TO: Dr. Jesse Bacon  
FROM: Bret Highley  
DATE: November 17, 2022  
RE: Change Order #22  
New BCPS 800 Student Elementary School

New BCPS Elementary School - 800-  
Student  
199 Golden Wing Road

Change Order Number: 022

Provision of a removable mullion at Door 001.1.

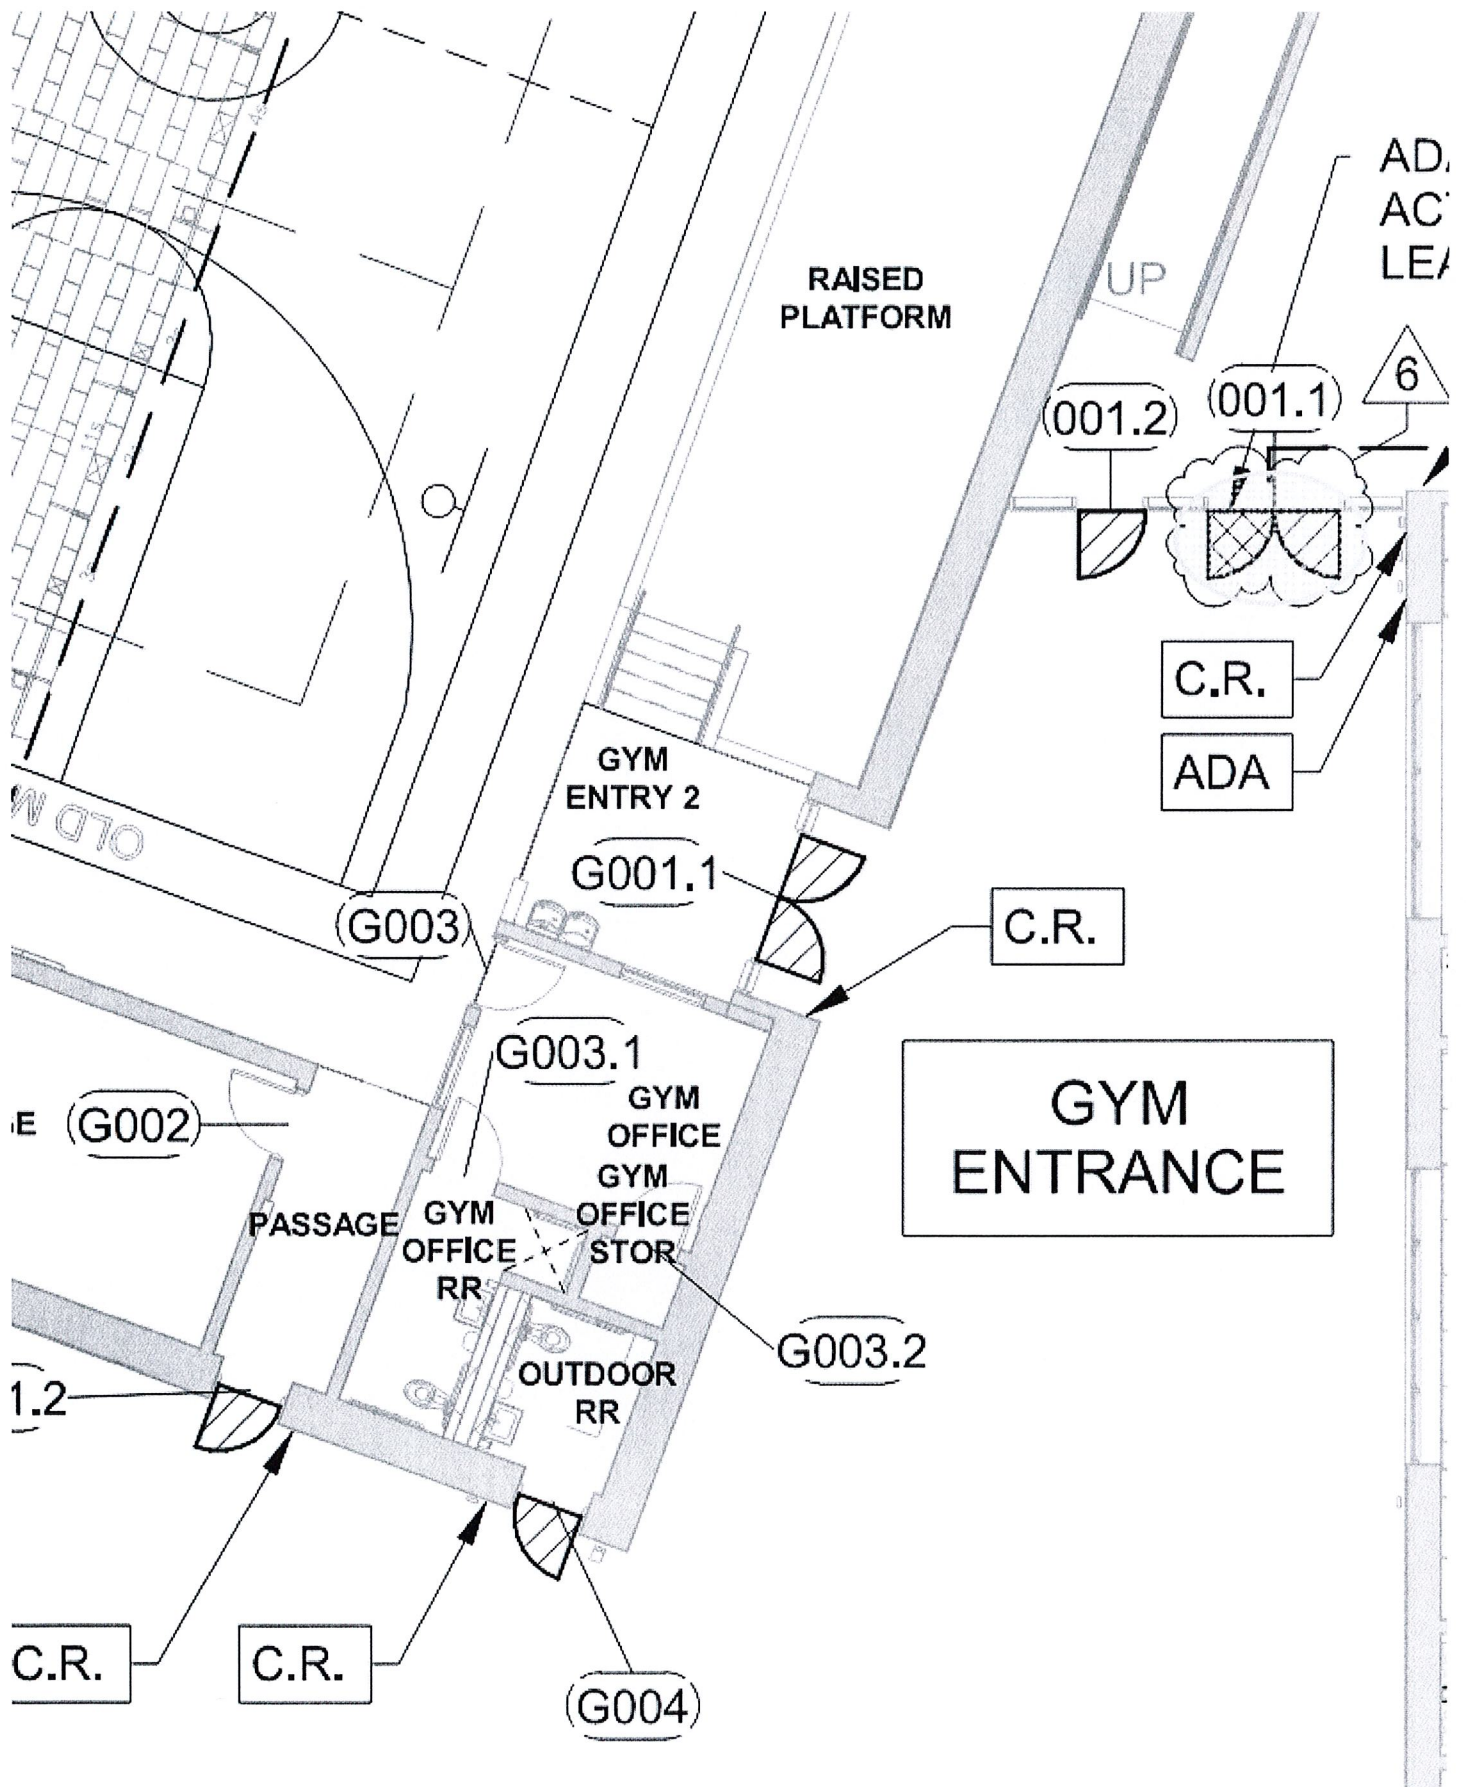
I had a question come up about locking mechanism at Door 001.1 at the Old Mill Elementary in Bullitt. This opening does not have a center mullion. Can the specified hardware (revised via RFP 06) be configured to lock successfully without a center mullion or do we need to make a change to the hardware specification here?

The hardware specification is snipped in below as well as the floor plan area with this door shown. The full RFP is attached for reference.

Can't remember if we discussed.... Door opening 001.1 from RFP 06... no mullion was called out for these doors. Were these handled in a different way? I'm not finding correspondence.

It needs a center mullion. This is what it needs:

(1)	Key Removable Mullion	KR-4954 x 154	689	VON
(1)	Mortise Cylinder	Primus LFIC 6-pin	626	SCH
